EA ref: WA/2018/125209/01-L01

LPA ref: WA/2018/0797

**Erection of 2 dwellings and a detached garage along with associated landscaping.  
30 Frensham Vale, Lower Bourne, Farnham, GU10 3HT.**

**Report supplied by Dr Paul Garrad BSc PhD AMCIWEM dated 22<sup>nd</sup> September 2018.**

Figure 1 Stilwell FRA Flood Map (FRA Appendix G)

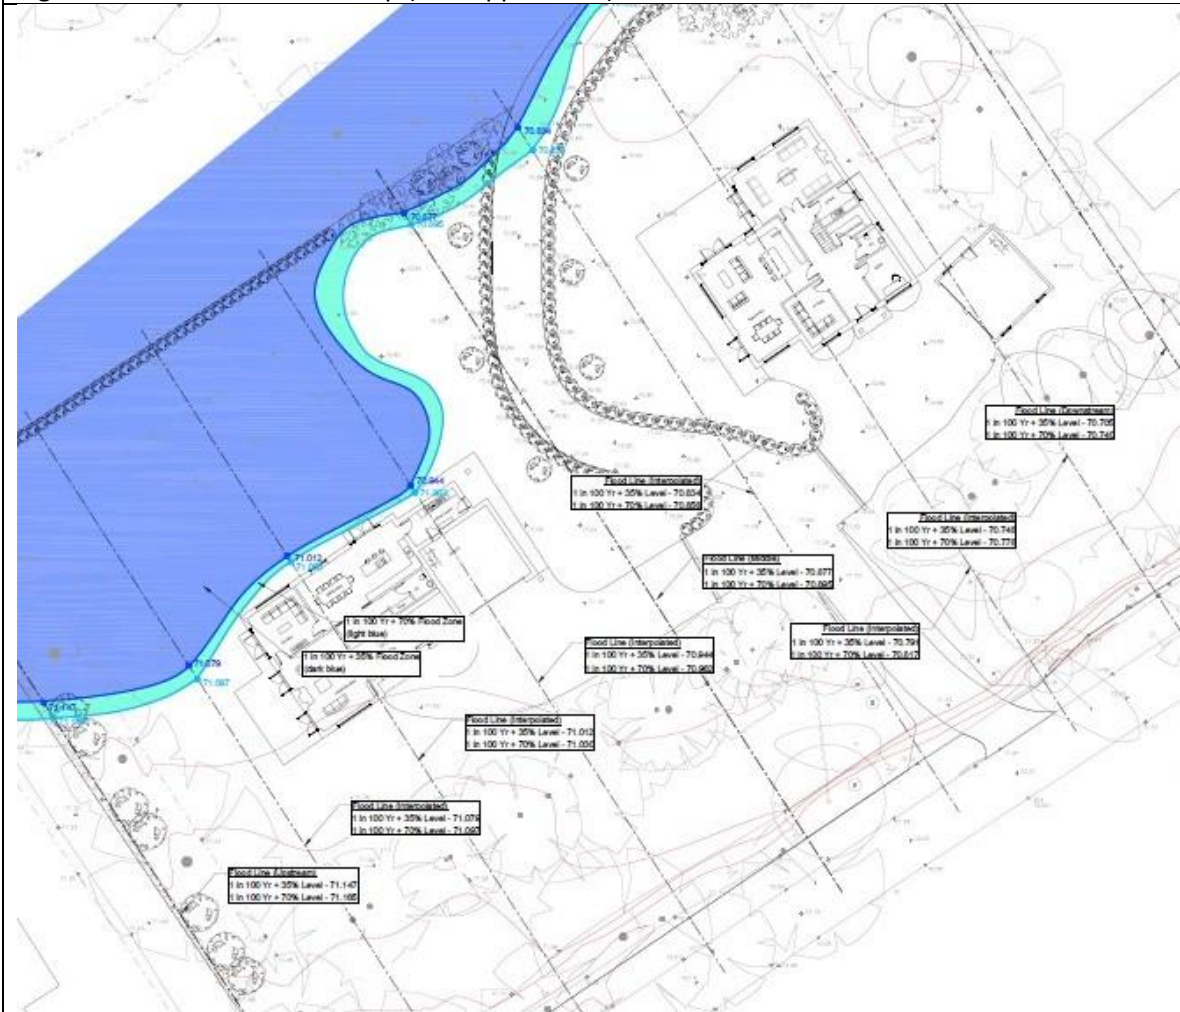
The EA flood map provides a similar flood outline as the maps in the HR report but the map in Appendix G of the FRA is far less extensive which is odd as the HR and FRA maps are based on the very same flood level data. This should have been explained and justified before the EA accepted the revised flood map in

the FRA and withdrew their objection. The only possible explanation, as the flood levels are the same, is that the FRA has used different ground survey data but then superimposing HR modelled flood levels which are based on a 2012 source of LiDAR data onto a different or new ground level survey, whether LiDAR or traditional, will often result in different flood extents and **technically this is not acceptable**. The flood maps should only be drawn on the same topo data from which the flood extents were derived on which the model was based. The other cause would be if there have been large scale land level changes on the site and on the flood plain but if this has occurred this would have been undertaken without planning permission. For these reasons we do not believe the FRA flood map is a true or accurate reflection of the flood risk on this site.

- Appendix G of the FRA shows that the difference between flood levels and ground levels at the building plots is small so that even a small margin of error in the calculations could make a difference to the flood map extents.

Figure 3 EA Flood Map (EA Web site)

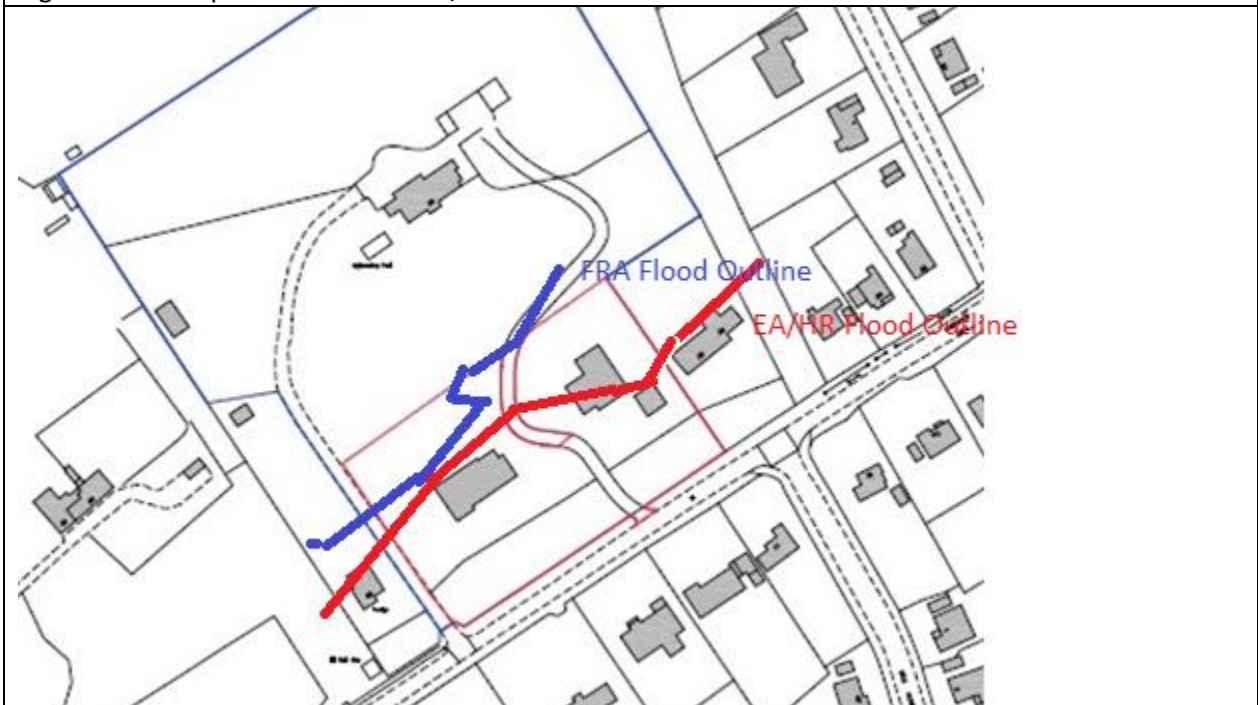
The applicant revised the FRA and this concluded the site was in Flood Zone 1 by superimposing flood levels from a Hydraulics Research (HR) model developed in 2012 onto a new topographical survey which showed the proposed development plots are above the predicted flood levels and flood extents as shown in Appendix G of the FRA (Figure 1). This is contrary to the HR report which showed the site was Zone 3 (Figure 2) the same as the EAs flood maps (Figure 3). There is clearly a discrepancy between both the EA and HR flood maps and that provided in the FRA.

- There is no explanation as to why the flood maps provided in the HR report, which show a similar flood outline as the EA flood maps, were not adopted other than they show the site is in Zone 3 and this would not remove the EAs objection.
